TECHNICAL SPECIFICATION FOR

CONTACTOR AUXILIARIES

FOR 3-PHASE ELECTRIC LOCOMOTIVES.

Specification No : CLW/ES/3/0201 ALT.E

(A) CONTACTOR:

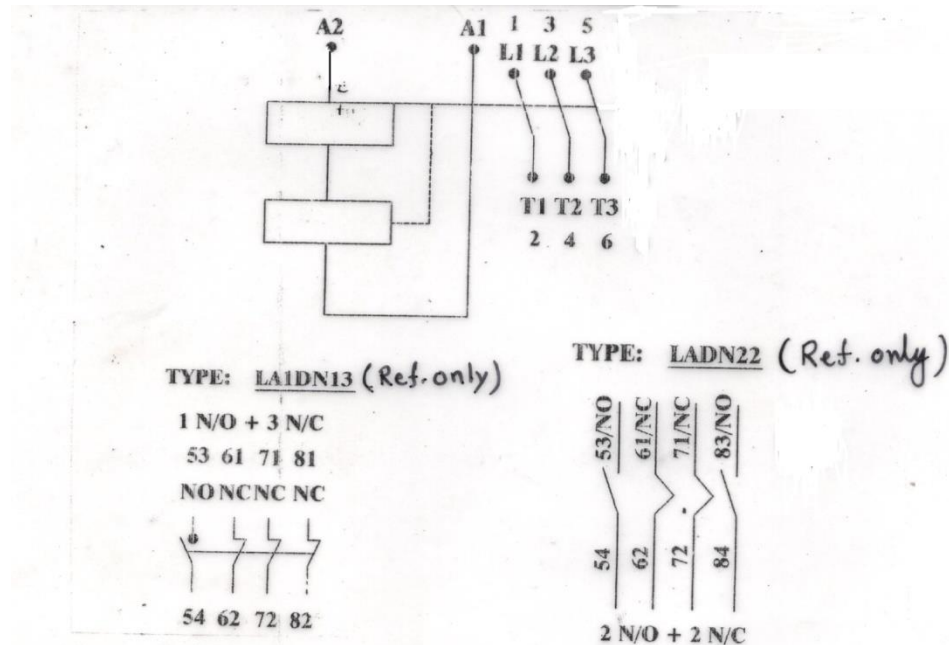
- Maximum Power Rating : ~~160 KW~~ **132KW**
- Rated Insulation Voltage : ~~1500V~~ **1000V**
- Rated Operational Voltage (Ui) : ~~1000V~~ **<= 1000V AC 50/60 Hz**
<= 460V DC
- Rated Making Capacity ~~1ms at 415/~~ at 440V : ~~1700A~~ **2720A**
- Rated Breaking Capacity at 440V : ~~1500 A~~ **2050A**
- Short Time Rating : ~~1200 A~~ **1.8 KA ----10s**

5.	XX.XX.2024		ix) Technical data sheet has been changed as contactor rating changed from 150A to minimum 200A as per guideline of RDSO vide letter no EL/2.1.8 dated 11.07.2024.	
----	------------	--	--	--
